# Response to An Bord Pleanála Pre-application Consultation Opinion

Proposed Strategic Housing Development on the former Player Wills site and undeveloped land owned by Dublin City Council at South Circular Road, Dublin 8.

December 2020

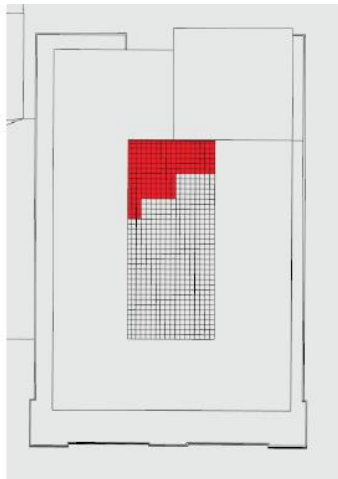
*Further consideration/justification of the documents as they relate to the overall layout/format of the shared living accommodation in PW1, including consideration/justification for the large number of units per floor on levels 1-4 and lack of a cluster format; consideration of the quantum of shared living/kitchen space per bedspace, as well as location and number of satellite kitchens proposed per floor; sunlight/daylight analysis of rooms on entire floor 1, showing acceptable level of residential amenity for future occupiers, in addition to overshadowing analysis of the central courtyard area.*

The proposed layout provides for each private living area to act as a singular distinct entity which is accessed from a corridor that extends the full length of the building. This linear layout allows for appropriately distributed communal kitchens which feature glazed corridor-facing walls that create punctuations of light and enhance the usability of these spaces (See **Drawing No's. PL1100-PL1102**).

On each level are 2 no. primary combined kitchen & living areas supported by satellite kitchens as set out in the table below. Following the pre-application consultation meeting with An Bord Pleanála, the quantum and distribution of the proposed shared kitchen/dining areas was reconsidered. This design exercise ran in tandem with the addition of 47 no. Build to Rent units in PW1 and the reduction of shared accommodation units from 331 no. to 240 no. As a result, the distribution of kitchens has been notably improved, and now provides for a

maximum distances of c. 21m from a private living space to the kitchen/dining area, and thus each kitchen is easily accessible to all proposed private living areas.

TOWER DESIGN EVOLUTION

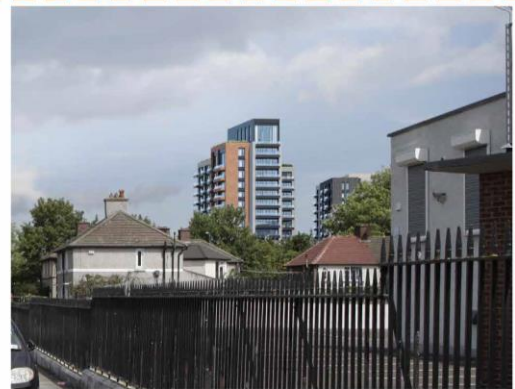
*Further consideration/justification of the documents regarding the slenderness of the towers in PW2.*

Since the preparation of the **Masterplan** (submitted under separate cover), the design of the 2 no. towers has evolved and developed significantly. This evolution in the slenderness profile is illustrated overleaf when you compare View 3 which shows the design in October 2019, compared to View 18 is which is the scheme being submitted for this application.

The articulation of the towers in PW2 has been developed to respond to the shared desire of Dublin City Council and An Bord Pleanála for a more slender expression, whilst responding to the fundamental demands of building efficiency and the efficient use of urban land. By breaking down the mass of each tower into distinct elements, the towers as proposed to incorporate an expression of a grouping of taller units, each of which is more-slender than the target 3:1 ratio as illustrated below.

## PW2 CORRIDOR ARRANGEMENT FOR ABP PAC & CURRENT PROPOSAL

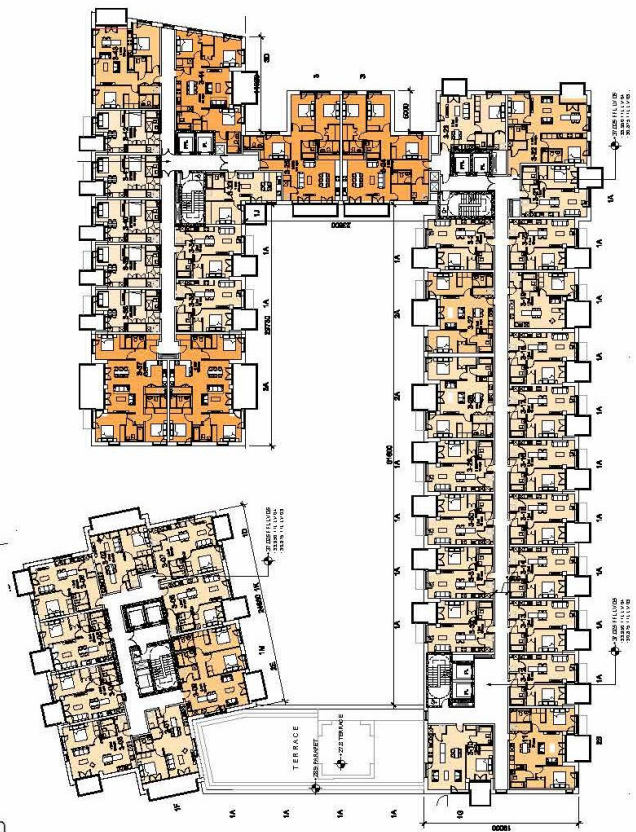
*Further consideration/justification of the documents in terms of the number of dual aspect units in PW2; number of north facing single aspect units; internal layout with long corridors; sunlight daylight analysis; and wind-microclimate study.*

Following revisions to the layout of the PW2 building as discussed above, one north facing single aspect unit per floor was revised to incorporate an additional west orientated window, which has incorporated an additional 14 no. dual aspect apartments.

The increase in dual aspect units as outlined above decreased the length of the corridors. The south east core has been relocated (1 structural bay towards north), to allow the layouts to be split and comply with adequate travel distances. The reconfiguration of these units resulted in improvements to the layouts of the common corridors.
